# Public Notice

## Virtual Public Hearing About Coffin Butte Landfill's Proposed Air Quality Permit on May 12 and Request for Public Comment Informational Meeting Before the Hearing

**Facility name:** Coffin Butte Landfill

**Permit type:** Title V permit

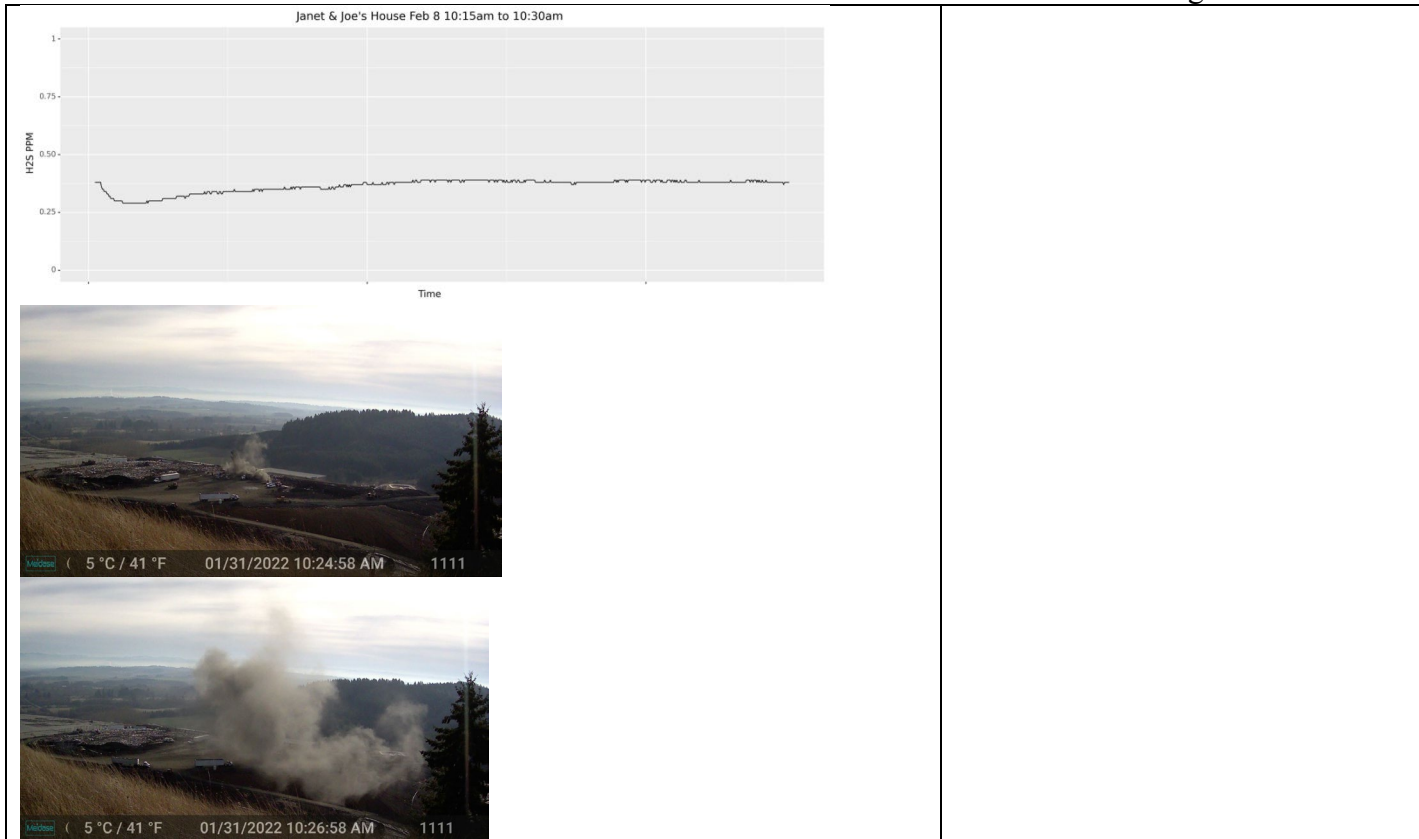
After listening to your Title V Permit renewal public hearing on May 20, 2025, I am writing to comment about what I believe are the inadequate conditions and voluntary compliance being asked of the applicant. Republic Services/Valley Landfills' current operational conditions create a nuisance for surrounding property owners and residents. With increasing frequency, we live with the negative air quality impacts, obnoxious and noxious odors, which we experience as "dump days". I will focus on only one of the many landfill stench odors we experience, hydrogen sulfide (H<sub>2</sub>S). I am submitting examples of data confirming obnoxious levels of hydrogen sulfide (H<sub>2</sub>S), mixed with other foul-smelling molecules near the Soap Creek Schoolhouse, 4 miles southwest of the dump. I do not know how to convert your proposed PSEL of 11 tons/year to parts per million or billion. However, the applicant used an assumed value of **36 ppm** for their Title V permit in their proposed expansion CUP application. This is an undue burden on our community. The EPA states that the public recognizes H<sub>2</sub>S at **2 – 3 ppb** (billion). Our data shows 250 - 500 ppb, or 0.25 - 0.50 ppm. I experience the vagaries of how landfill stench moves on my daily jogs, as winds are impacted by cloud cover, elevation, topography, temperature and humidity. At mid-valley and tucked behind a knoll at 500 feet, we get both Pacific Regional Compost (PRC) and Coffin Butte Landfill (CBL). At the bottom of our ¼ mile driveway, at 400 feet, dump odors are more frequent. I look outside for inversion or cloud banks, which direction they are moving and the color to decide which way to go. Sometimes I get a visual cue, other times not.

I have occasionally reported to DEQ when the odors are nauseating and only at my house. One DEQ report had Republic Services investigation that said nothing was smelled by their staff, however a dead skunk was seen on the road. Soon after, I reported on a blast from PRC, so they and you would know, we know the difference between compost, landfill stench and skunk. In a former life, I worked in sensory science, where there is a condition, called anosmia or smell blindness, that can be caused by over exposure to a particular molecule. One known cause is exposure to hydrogen sulfide which causes paralysis of the olfactory nerve.

Exhibit 2 Coffin Butte Landfill Location Orientation Looking West

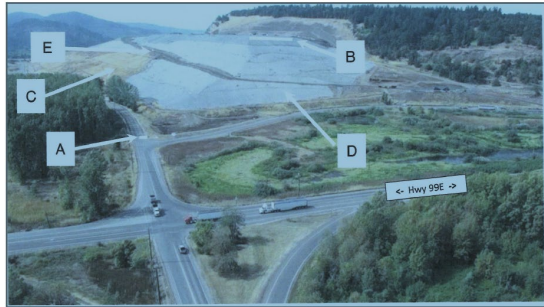
The white plume dimensions are difficult to estimate. Assuming the trash truck is 13 feet tall, the plume seems to be on the order of 400 feet to tall and 700 feet wide in the top photo. Shortly thereafter the plume height seems to be on the order of 250 feet to 400 feet tall and more than 800 feet wide. In both photos the plume is moving to the south. For location information, see Exhibit 2.

- A - Approximate location Plume Photos taken
- B - Approximate location truck tipping area / working face of landfill
- C - Soil covered area (typical)
- D - Plastic or rubber covered area (typical)
- E - Haul road for vehicle traffic within the landfill.

**Exhibit 3 Bursting Bagged White Wastes**

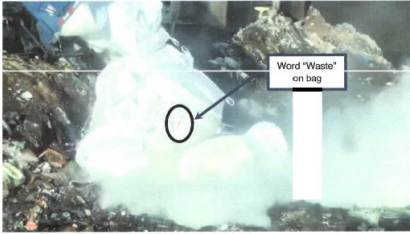
Waste designation on tote bag evident as "red" lettering.

**Dust Clouds (Particulate Emissions) from Coffin Butte Landfill**

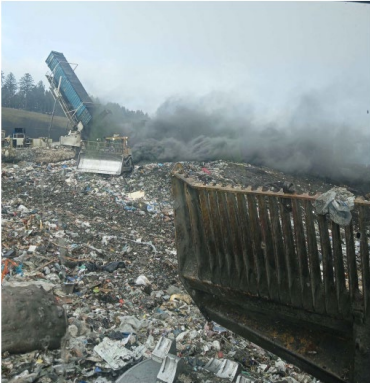
Testimony from Mark Yeager, Corvallis, Oregon, June 5, 2025.  
Title V Air Quality Permit for Coffin Butte Landfill, 02-9502-TV-01
